STAFF REPORT: SEPTEMBER 22, 2021 MEETING

APPLICATION NUMBER: 21-7122 REVISED

ADDRESS: 8002 KERCHEVAL

SCOPE OF WORK: INSTALL NEW SIDING, LIGHT FIXTURES, AND SIGNAGE

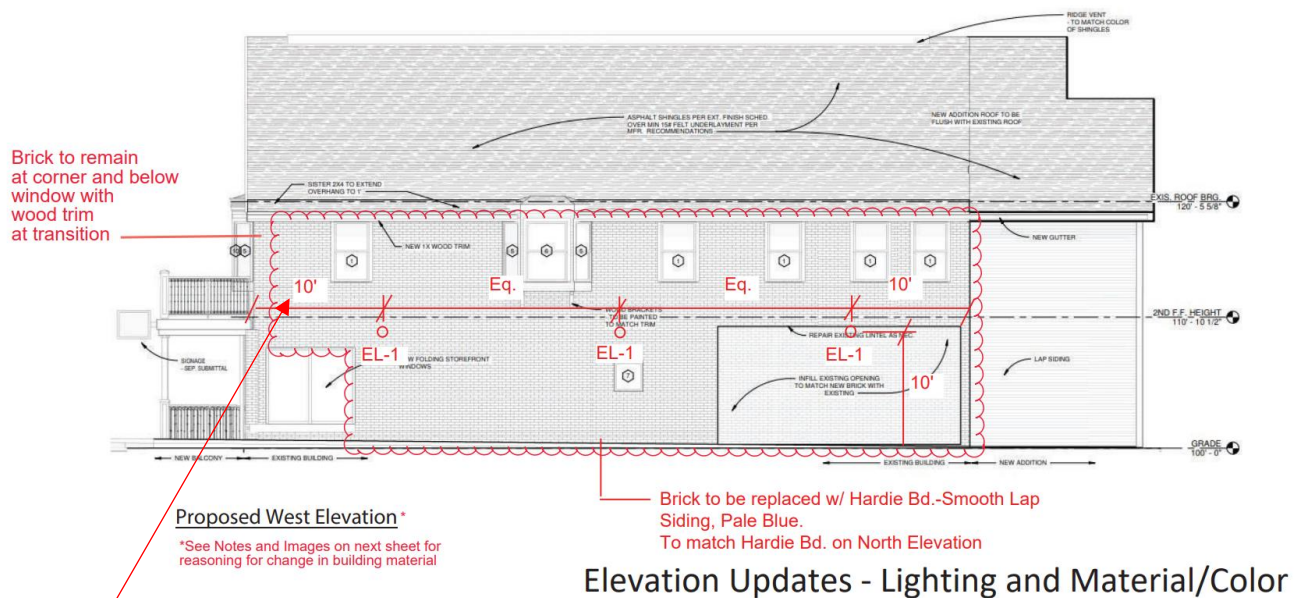
- It is staff's opinion that the proposed Smartside siding as installed at the rear elevation new addition is not a good replication of historic lapped wood siding as the exposure is too wide and the profile is too thin. Staff recommends against approval of its installation on the **original building's primary elevations** (the north and west elevations)

- See below line drawing of the proposed east elevation, which indicates the area where the applicant is seeking to replace the existing brick veneer siding with new lapped siding. annotated photo. It is staff's opinion that proposed installation would result in an appropriate "stepping" of the siding into the second story above the primary storefront window and would improperly overlap a secondary elevation treatment over a primary elevation treatment. Instead, staff recommends that the primary elevation's expression of the brick framed storefront with second story brick be wrapped around the west elevation to fully include the Van Dyke storefront window and eliminate awkward and inappropriate stepped effect which would result from the proposed application. See the below annotated photo below for staff's recommended transition between the brick and lapped siding at the west elevation. Although staff feels that it would be appropriate to continue and restore the brick down the full length of the Van Dyke (west) elevation, which is also quite prominent and visible, should a lapped siding be installed a transition point along a single vertical line (shown in red, location approximate) would be minimally appropriate so that the building properly "holds" the corner.

The applicant proposes to install the lapped siding within the red, bubbled area

Should the applicant install lapped siding at the original building, west elevation, staff recommends that the installation begin to the right of/south of the above red line.

- The new siding which shall be installed at the front/north elevation gable end and the side/west elevation of the original building shall be composite (with a smooth finish) or wood, lapped, and display an exposure of no more than 4 ½" and a profile between ½" and 5/8". Staff shall be afforded the opportunity to review and approve the siding/revised construction documents. Should staff determine that the proposed siding does not meet the Standards or the Commission's intent, they shall forward the proposal to the Commission for review at their regular meeting.

- Should the applicant install lapped siding at the west elevation, brick must be maintained at the west elevation's northeast corner past the Van Dyke storefront at the first and second story per

the above annotated photo. Final drawings which detail this condition shall be provided to HDC staff for review and approval prior to the issuance of this COA
